Sunfield Fast-track

Auckland Council Specialist Memo

Healthy Waters and Flood Resilience Memo

4 August 2025

Figure 6-4: CN61 10-year ARI historical rainfall – showing predicted flood depth increase at building footprint.

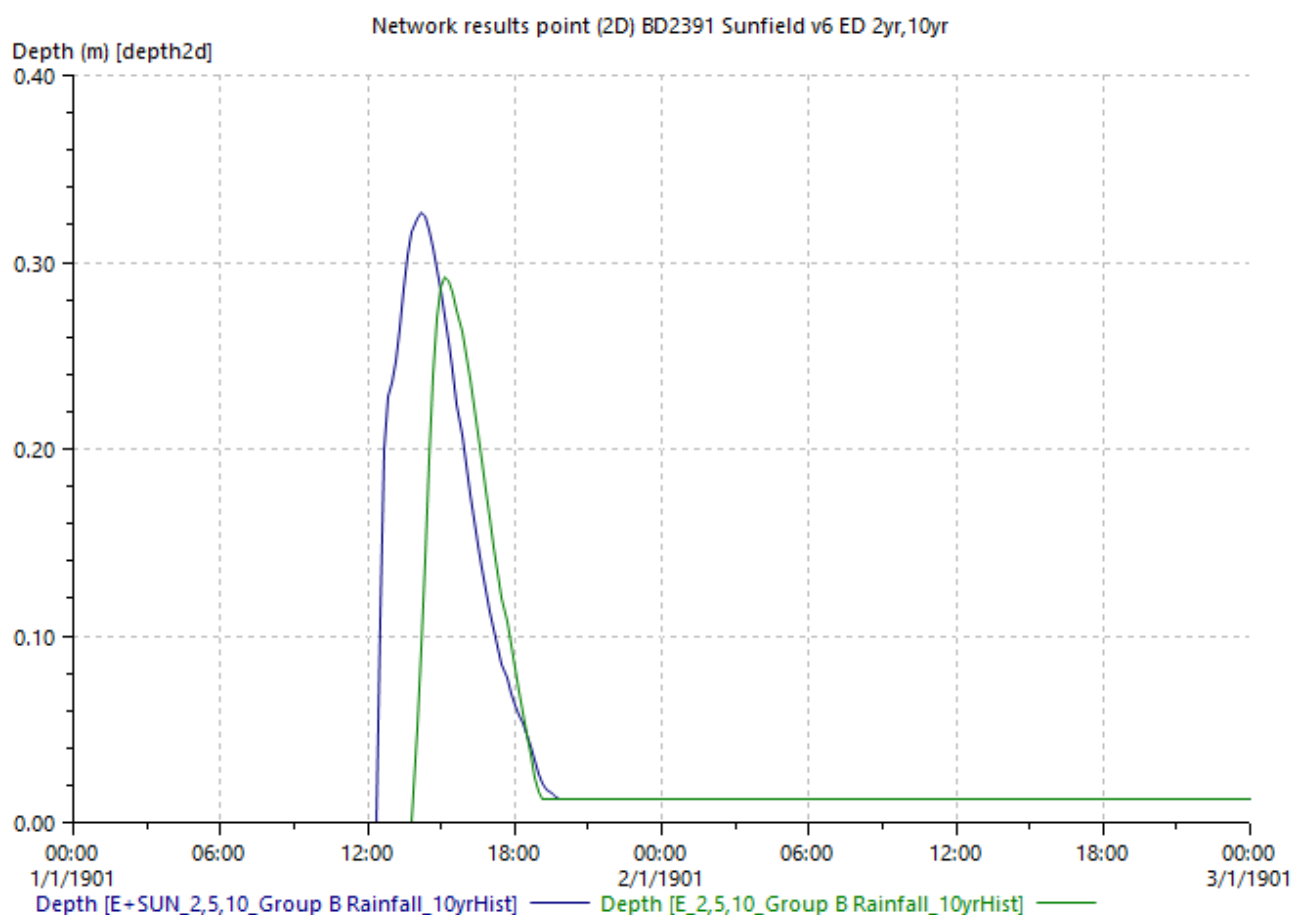
Figure 6-4 shows the increase in predicted flood depth at a building downstream of pond 1 in the 10-year ARI CN61 scenario. The location of this building is shown in Figure 6-5. This result is not apparent on the flood depth difference maps as the increase is less than 50 mm, however it is still a negative impact that should be considered.

Figure 6-8: Predicted operation of pond 2 in 100 year ARI E+SUN scenario, CN 61.

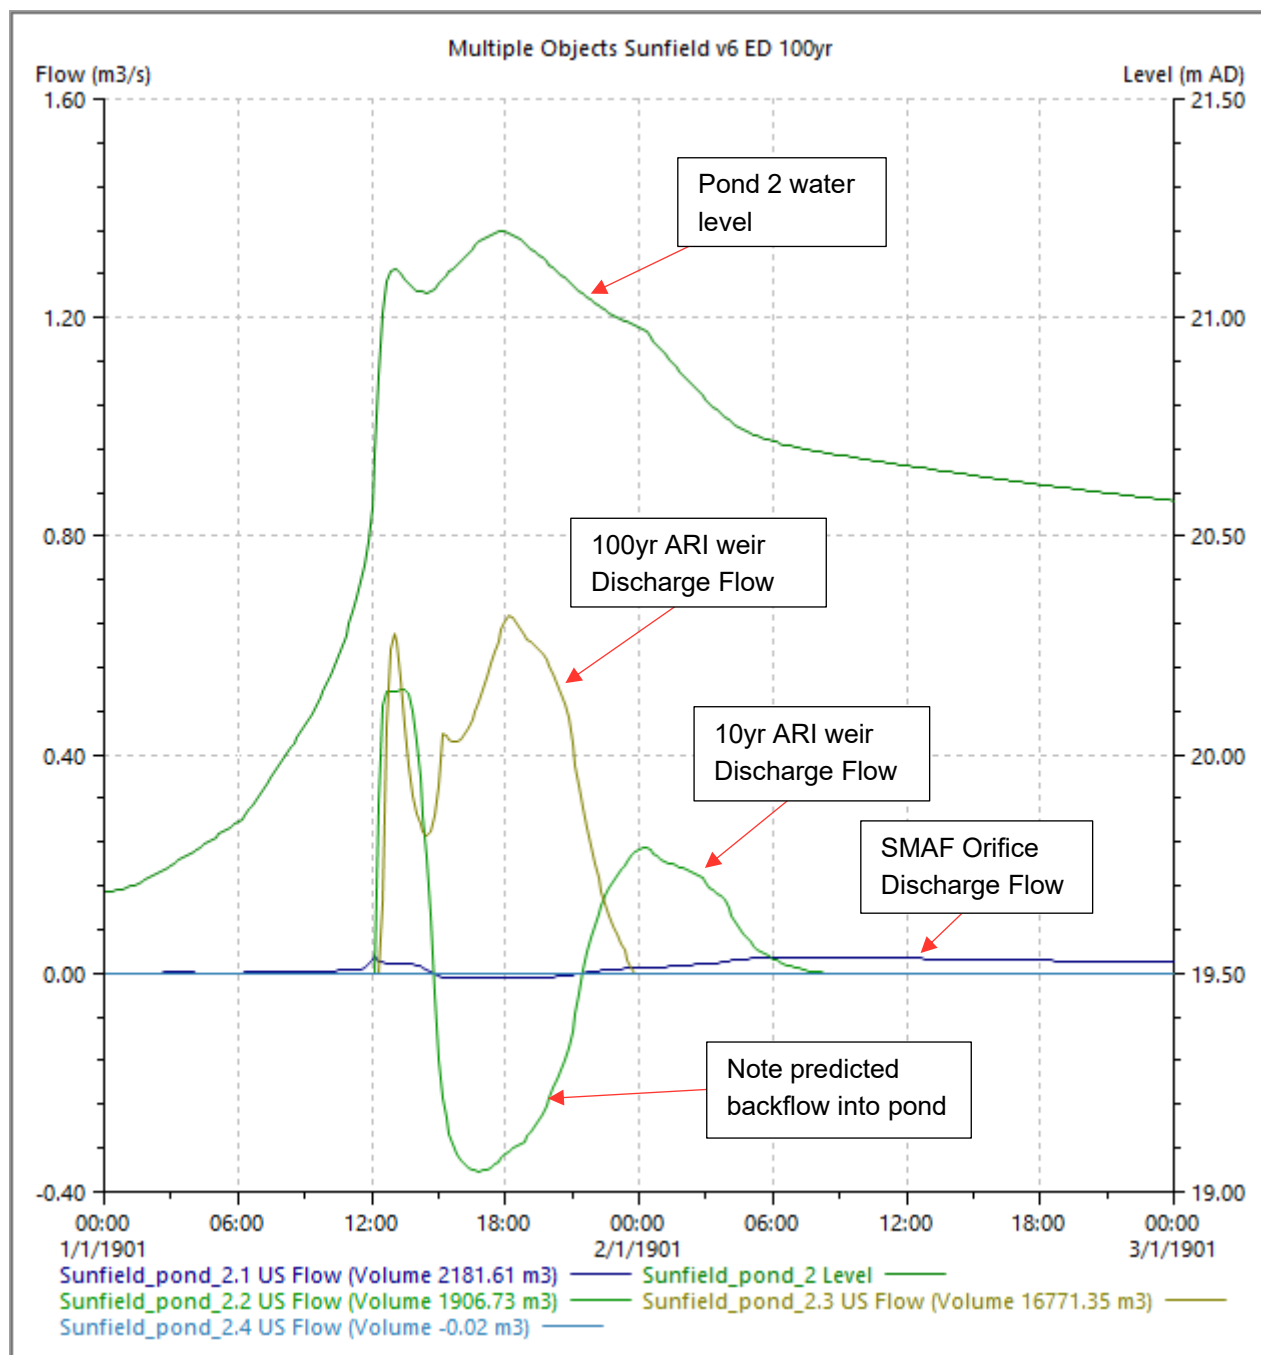
Our modelling indicates some backwater issues at pond 2 and 3. Figure 6-8 shows the flows through the different outlets from Pond 2, as well as the pond level on the secondary Y axis. Due to the high downstream water level the model predicts backflow into the pond via the 2m wider “10 year ARI” weir.
